ASHLAND PLANNING DEPARTMENT
PRE-APPLICATION CONFERENCE
COMMENT SHEET
December 18, 2024

SITE: 526 Waterline
APPLICANT: Chris Brown for Percept LLC
REQUEST: Physical & Environmental
Constraints Review for Hillside Development -
new SFR

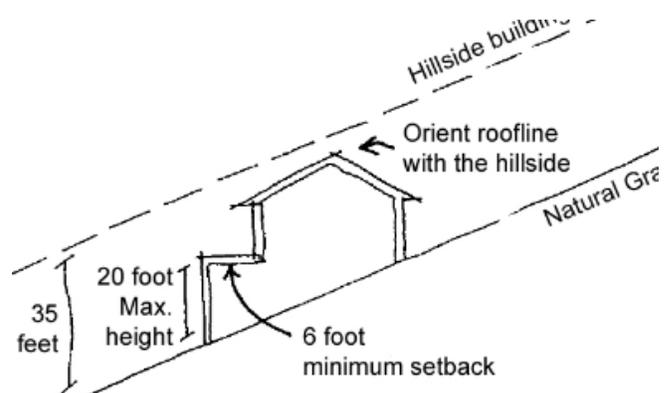
The property located at 526 Waterline is a steeply sloped lot. With close to 100% of the lot labeled as ‘severely constrained’ (slopes greater than 35%). On the image to the right (generated by City GIS) the dark magenta are slopes greater than 35%, light magenta are slopes greater than 25%, and no color are slopes less than 25%. The land use ordinance requires all new construction to happen on slopes less than 35%, however AMC 18.3.10.090.A.1.a allows for “Existing parcels without adequate buildable area less than or equal to 35 percent shall be considered buildable for one unit.” Because of steepness of the property and the presence of slopes greater than 35% a Physical and Environmental (P&E) Constraints Review Permit is required. As part of the P&E permit, the application must address the Hillside Development Standards in AMC 18.2.10.090 and the development standards for Severe Constraint Lands in AMC 18.3.10.110. The applicant’s submittals indicate three (3) different options for development. Each option will be addressed individually, with Option 1 being the “Bridge” option, Option 2 being the "Concrete Blocks” option, and Option 3 being the “Concrete Silo” option. Options will be addressed as “Option 1,” “Option 2,” and “Option 3.” Due to the number of options and the variation between them, staff recommends a follow-up meeting to discuss the selected option prior to submittal of an application.
